# Rix's Creek Continuation of Mining Project

Response to IPC Recommendations

**Client: Bloomfield Collieries Pty Limited**

**07-Dec-2018**

Figure 1 Bloomfield Group web page

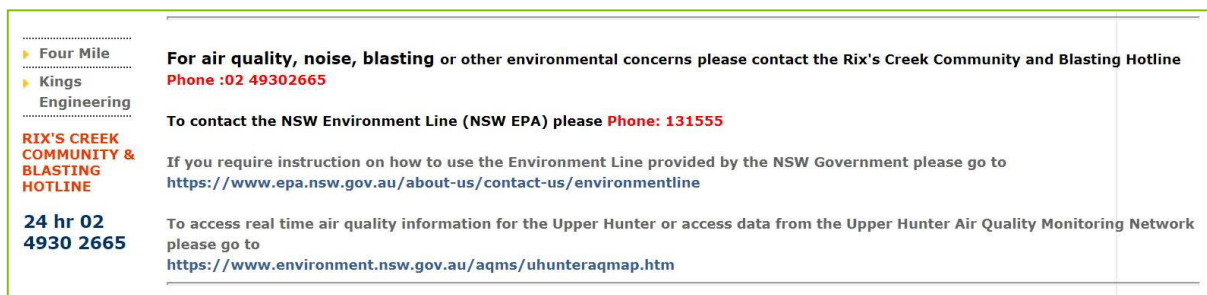
**R2 that the applicant develop a protocol to assist those stakeholders concerned about air quality impacts to better: - access the data from the Upper Hunter Air Quality Network; and - provide instruction on how to use the Environment Line provided by the NSW Government.**

- A link to the Upper Hunter Air Quality Network is provided on the Rix's Creek Operations page of the Bloomfield Website;
- Contact details for the NSW Environment Line (131 555) are provided on the Rix's Creek Operations page of the Bloomfield Website; and
- A link to the instructions for the use of the NSW Environment Line are provided on the Rix's Creek Operations page of the Bloomfield Website. A screenshot of the Rix's Creek Operations page from the Bloomfield Group's website is shown in Figure 1 and the contact details as shown on the webpage are shown in Figure 2.

**FIGURE 1**

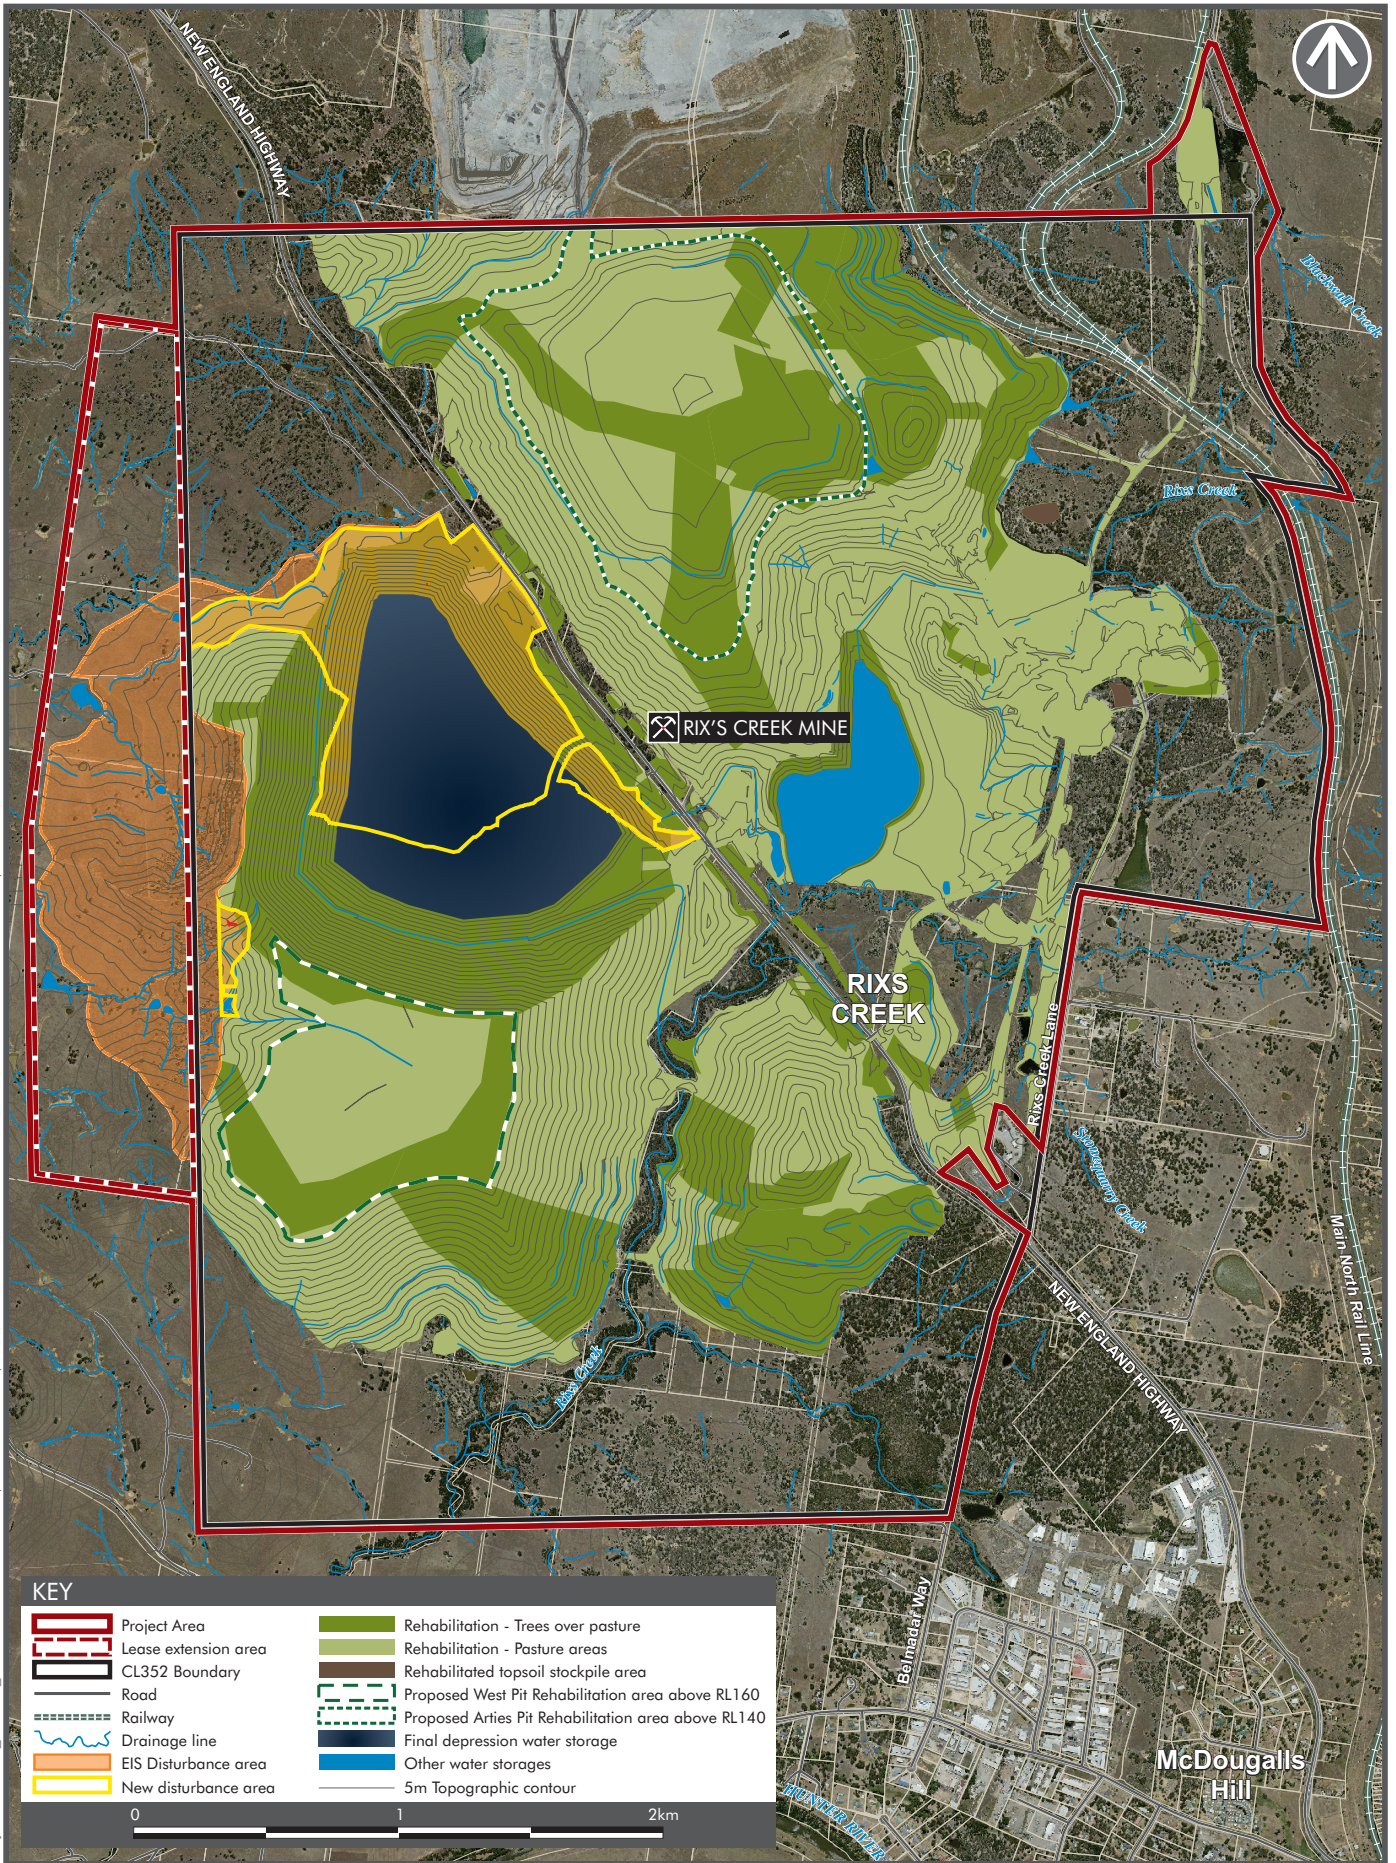
- **Option 1** addresses the requirement of recommendation 16 and removes the requirement for the western overburden emplacement area completely. Instead, overburden would be stored on the existing North Pit dump and South Pit dump, by increasing the height of these dumps. The direct benefit of this option is to remove the need to disturb and clear the land within the footprint of the Western out of pit dump; and
- **Option 2** reduces the area required for the Western out of pit overburden emplacement area by removing the requirement to dump on the southern portion of the Western out of pit dump footprint. The residual overburden would be placed on the existing North Pit and South Pit dumps, with the difference from Option 1 being that the footprint and height of the North Pit dump would be smaller and lower. The South Pit dump profile is the same in both cases.

The final landform for both Option 1 and Option 2 are shown in Figure 3 and Figure 4 respectively.

Figure 5 Comparison of incremental 24-hour average PM<sub>2.5</sub> concentrations (µg/m<sup>3</sup>)

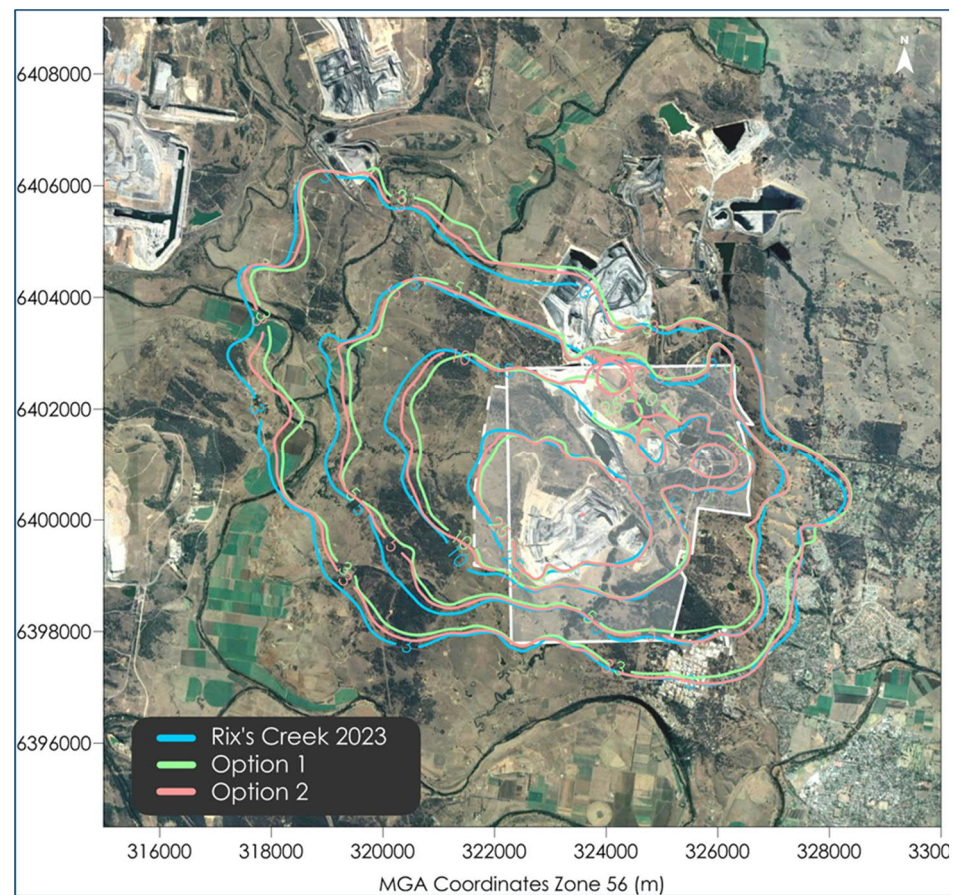
The dispersion modelling results comparing the predicted incremental 24-hour average PM<sub>2.5</sub>, annual average PM<sub>2.5</sub>, 24-hour average PM<sub>10</sub> and annual average PM<sub>10</sub> are shown in Figure 5 to Figure 8.

The activities associated with the proposed trade-off options are predicted to generate between 1.0 to 1.5% more dust relative to the original scenario for 2023. In actual figures this equates to 0.2µg of PM10 which is a minor increase. This change arises primarily due to increased haul distances.

Notably, the predicted change in dust impacts is small, and within the modelling accuracy and the normal variation that naturally occurs in background dust levels daily or between years.

The comparison shows that the proposed trade-off options would only influence dust levels in the close vicinity to the site of the activity and that no significant or reasonably measurable change in dust level at any off-site receptor would occur from the mine as a result of the proposed trade-off options.
